# SAN FRANCISCO PLANNING DEPARTMENT

## Addendum to Environmental Impact Report

*Addendum Date:* November 23, 2015  
*Case No.:* 2007.0558E and 2008.0789E  
*Project Title:* Folsom Street Design Update  
*EIR:* Transit Center District Plan Final Environmental Impact Report  
(Final EIR)  
SCL No. 2008072073, certified May 24, 2012  
*Project Sponsor:* Joshua Switzky, San Francisco Planning Department  
(415) 575-6815 and  
Greg Riessen, San Francisco Municipal Transportation Agency  
(415) 749-2571  
*Lead Agency:* San Francisco Planning Department  
*Staff Contact:* Christopher Espiritu – (415) 575-9022  
christopher.espiritu@sfgov.org

Figure 2A: Folsom Street Design (Embarcadero to Main Streets) – 2015 Project Update.

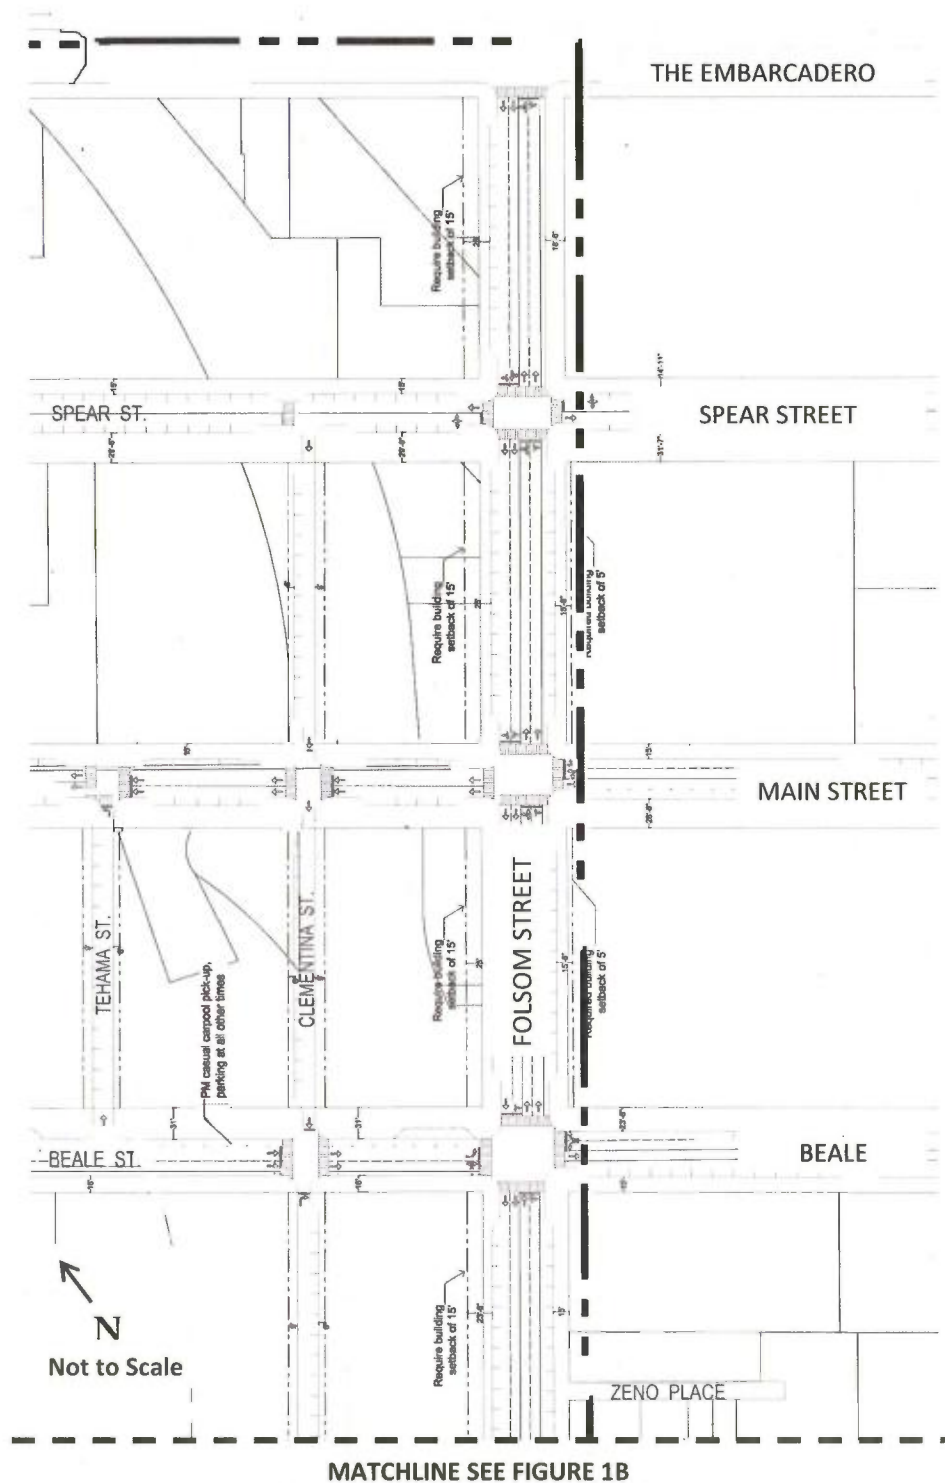
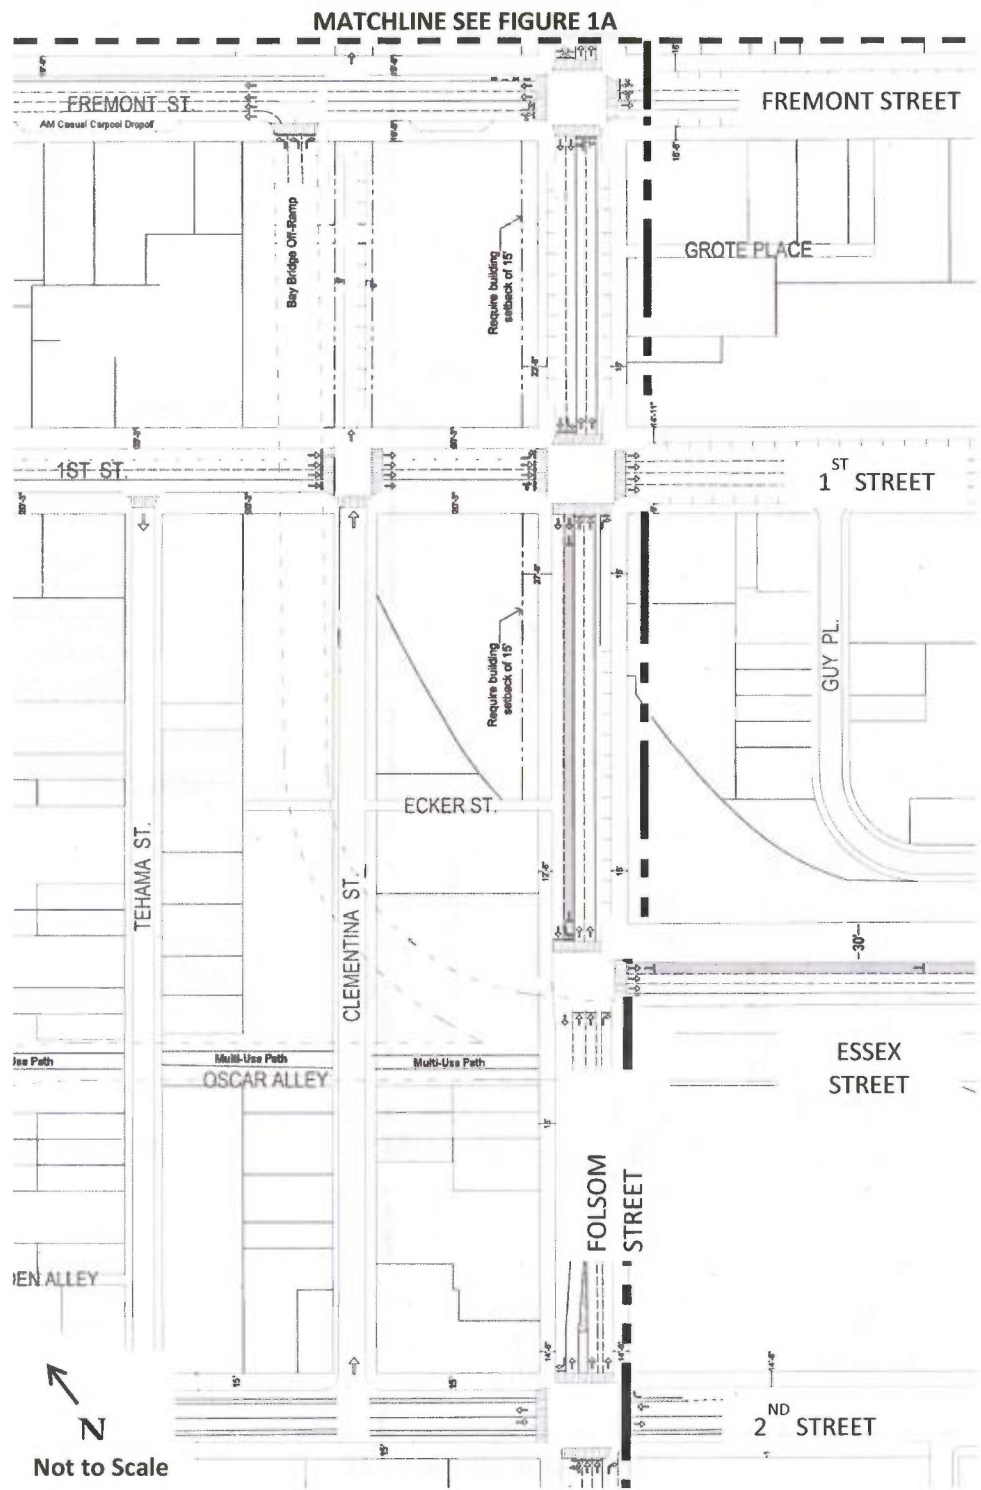
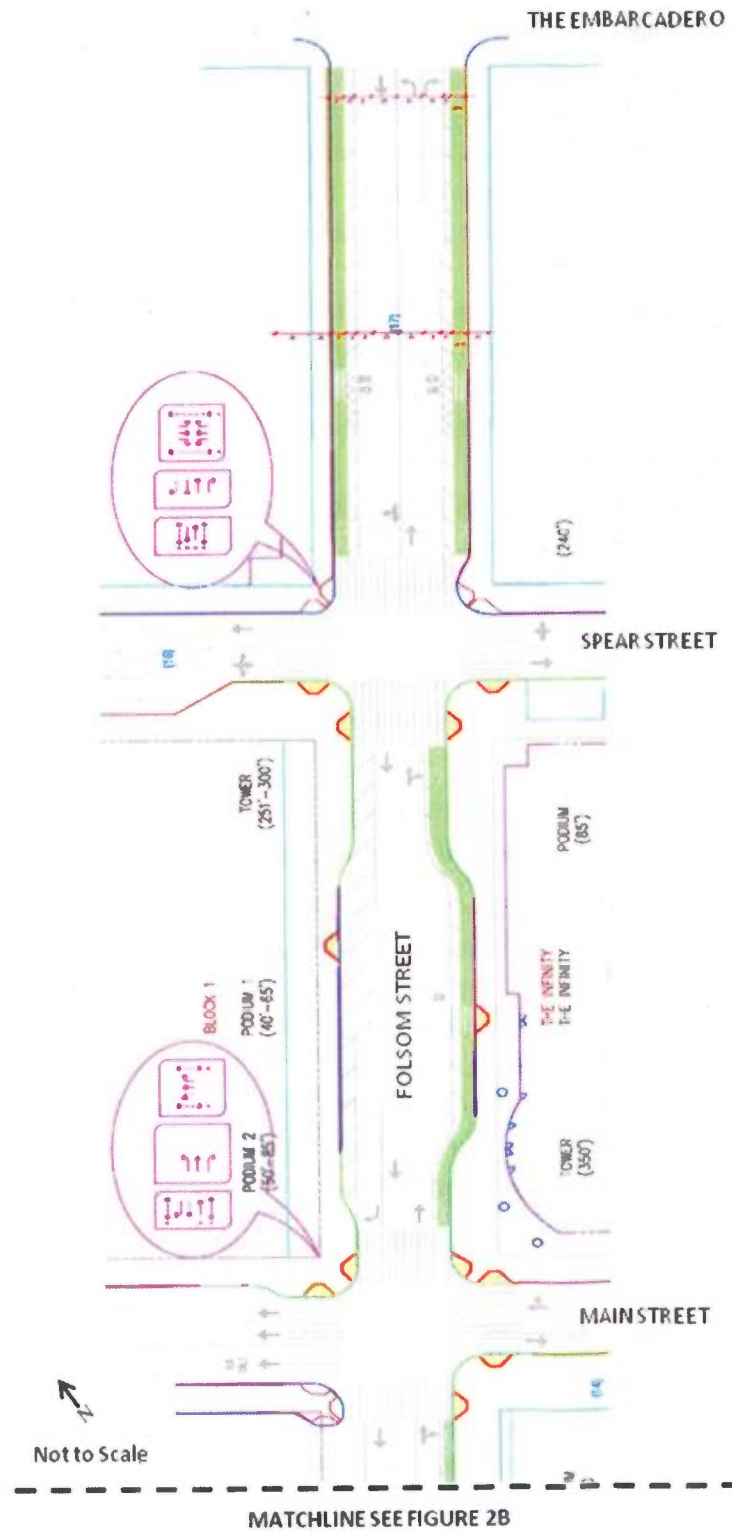
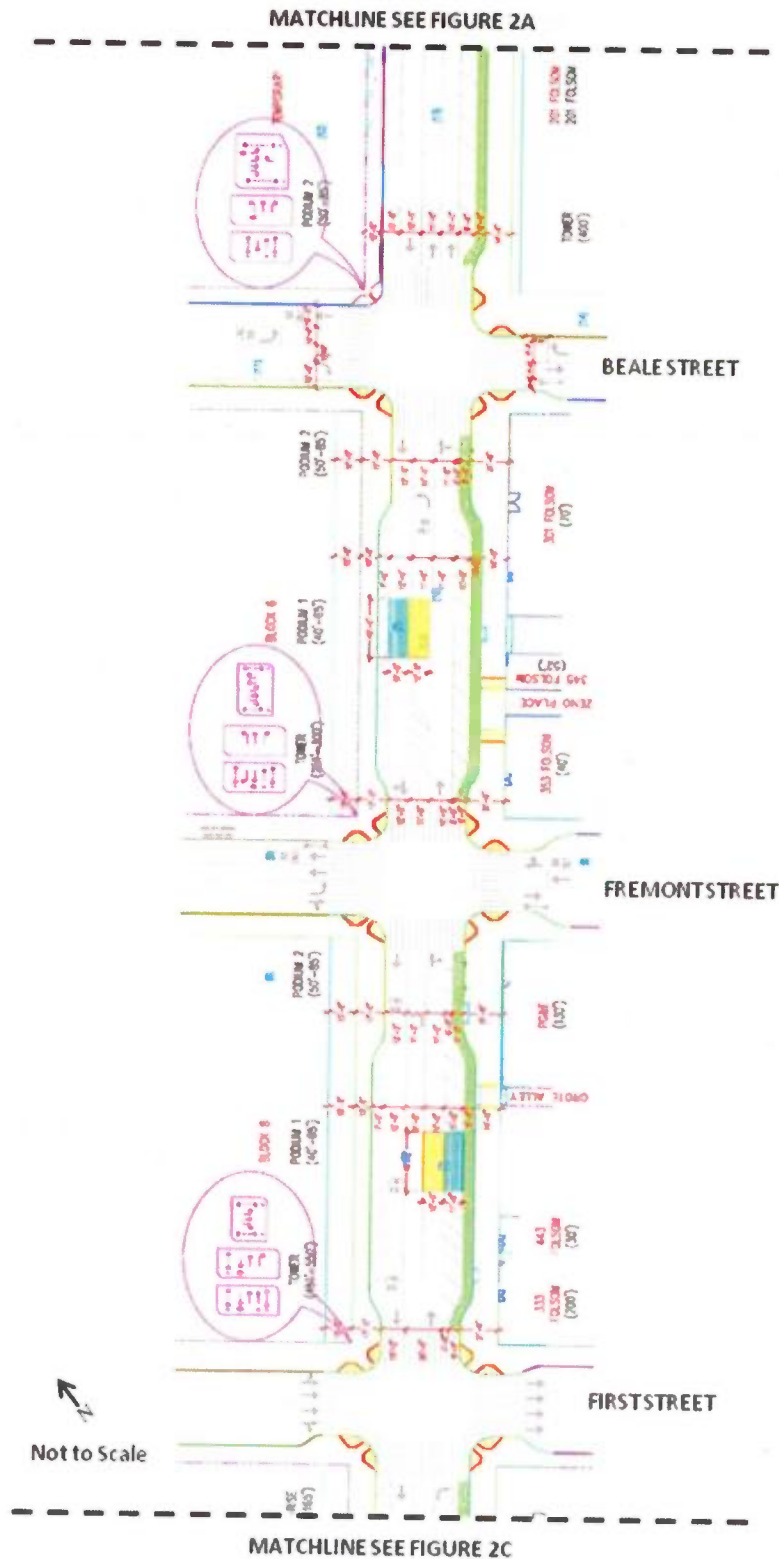
In order to address the schematic design issues related to the original Folsom Street Design, the SFMTA and the Planning Department conducted an assessment of the Folsom Street Design in 2015. A public meeting was held on July 16, 2015 to inform the community about the project status and proposed refinements to Folsom Street. To address the issues identified during the schematic design process of the initial Folsom Street Design, several components of the Folsom Street Design were updated and are analyzed in this Addendum. The following includes the proposed revisions to the Folsom Street Design and are shown in Figures 2A-2C.

- Instead of four travel lanes (two in each direction), the updated design includes three travel lanes (generally two eastbound and one westbound), which enables the lanes to be wider and more safely accommodate buses and other large vehicles. Consistent with existing conditions, the westbound lane along Folsom Street would be a transit-only lane between Fremont and Essex streets.

- On-street parking along both the north and south sides of Folsom Street between First and Main streets would be removed in order to minimize conflicts with bus operations. (On-street loading and/or parking spaces would be re-installed in 2018 upon the closure of the Transbay Temporary Terminal.)

- Instead of an eastbound bicycle lane along Folsom Street between Second Street and The Embarcadero, the updated design includes a protected cycletrack in order to enhance bicycle access and safety.

- Crosswalks would be widened at all intersections in order to enhance pedestrian visibility for drivers, and also to better facilitate large vehicle turn movements.
